REMARKS

Enclosures: Corrected Drawing Sheet for Figs 20A-20C, with changes marked in red; and
Submission of Replacement Drawing Sheet

FIG. 20A

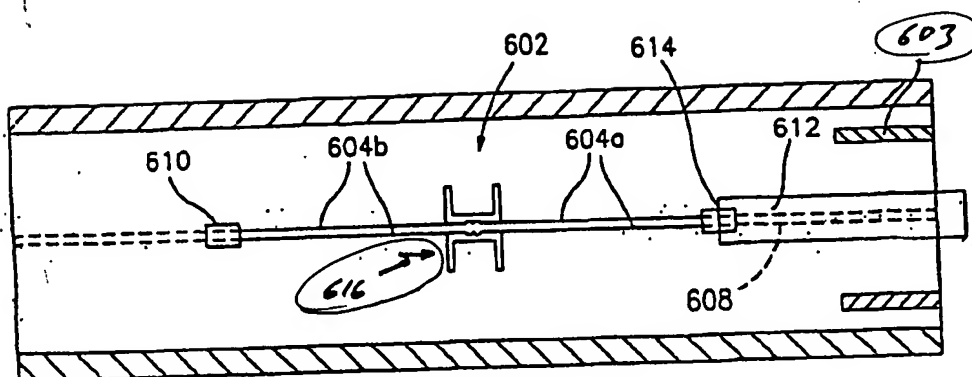
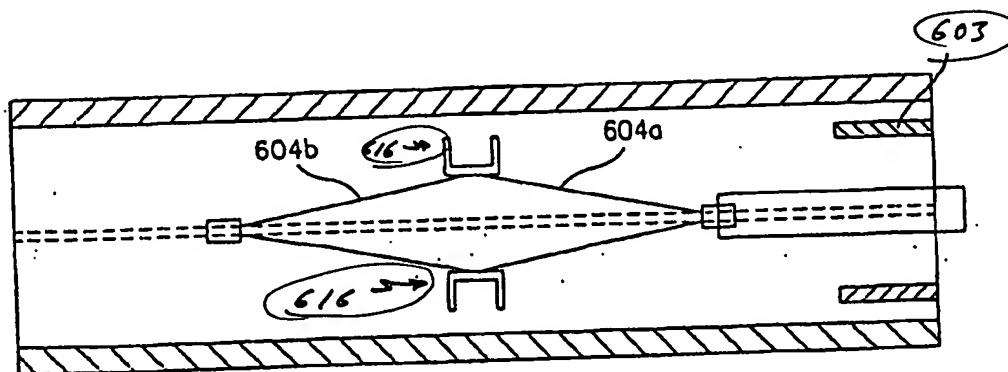
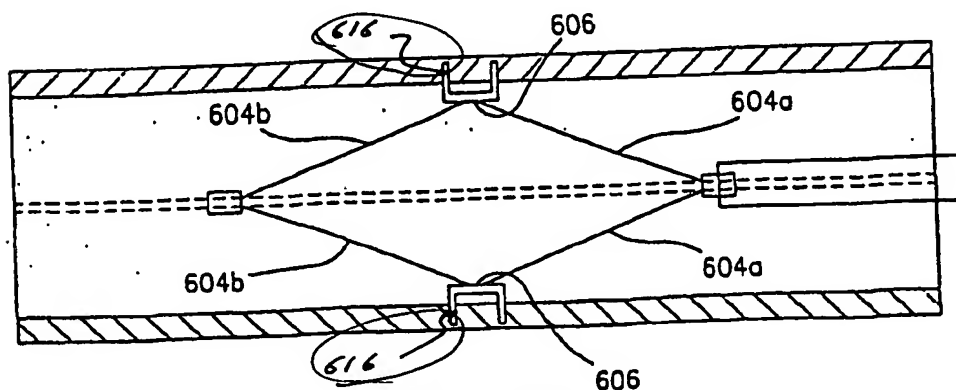
In regard to the objection to the drawings, at page 2, the Office Action indicated that reference numbers mentioned in the description are missing for item 616 in Figs 21A, 21B and 21C. In response, it is noted that paragraph 0051 of the specification has been amended to correct the reference from Figs. 21A, 21B and 21C to Figs, 20A, 20B and 20C. In addition, enclosed herewith for the Examiner's approval are corrected drawings for Figs. 20A, 20B and 20C that include numeral 616 requested in the Office Action as well numeral 603, in accordance with the description provided in the Specification. See ¶0051. Changes are circled in red ink for the Examiner's convenience. A *Submission of Replacement Drawing Sheet* is also enclosed, which is believed overcomes the objection.
